## MODIFICATION

This modification will be implemented in production from serialnumber: G0ZC52107201

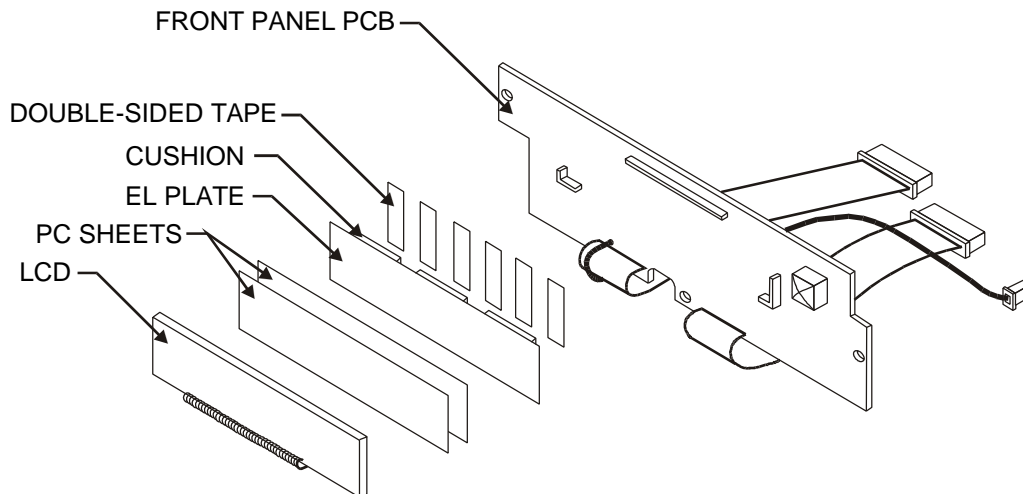
You may receive a complaint of the unit producing a very high whistle noise

The step up transformer for the display circuit is humming

1. Insert a transformer with more varnish impregnation
2. Apply glue to fix the step-up transformer to the main pcb
3. Add double sided tape between the cushion at the back of the EL display and the front panel pcb.  
Please refer to the drawing below
